Barillari Peat Removal Haddam, Connecticut

REPORT

Review Date: FEBRUARY 20, 1986

ENVIRONMENTAL REVIEW TEAM REPORT
ON
THE BARILARRI PEAT REMOVAL
HADDAM, CONNECTICUT

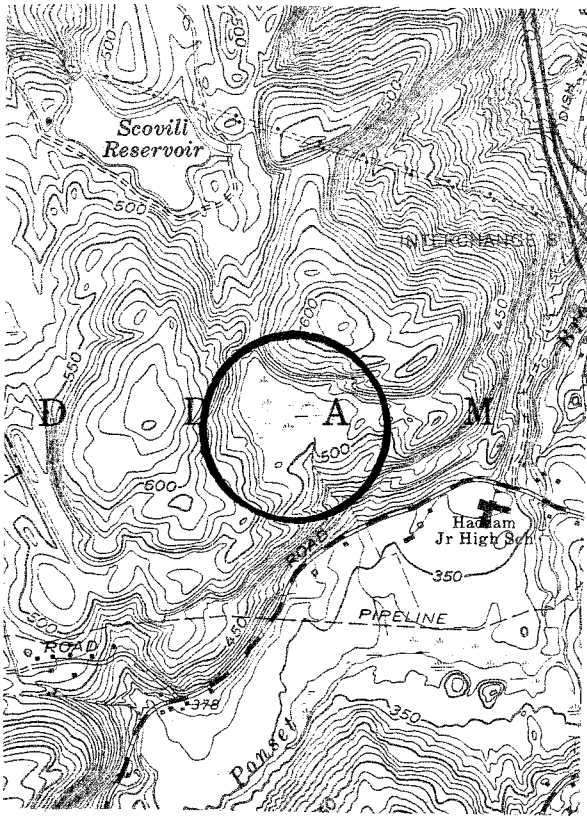
A detailed soils map of the site is included in this section of the report. Soil types were field checked by Marc Beroz, SCS Soil Resource Specialist, following the ERT site visit. One change made on the published soil survey map as a result of this investigation is indicated on the map in this report. Soil boundary lines on the map should not be viewed as absolute boundaries, but as guidelines to the distribution of soil types on the site.

The V-shaped symbols within the Hinckley soil unit indicate the presence of rock outcrops. Depth to ledge should be determined prior to siting on-site septic systems.

Along the southern boundary of the parcel are Canton and Charlton extremely stony fine sandy loams on 3 to 15 percent slopes (map symbol CdD). It is within this soil area that the developer proposes to obtain fill to create dikes along the existing stream channel and around the sediment basin. These soils have moderate to severe limitations as dike material due to seepage and piping. It is recommended that the material be tested for its suitability and an alternative source of suitable material be identified.
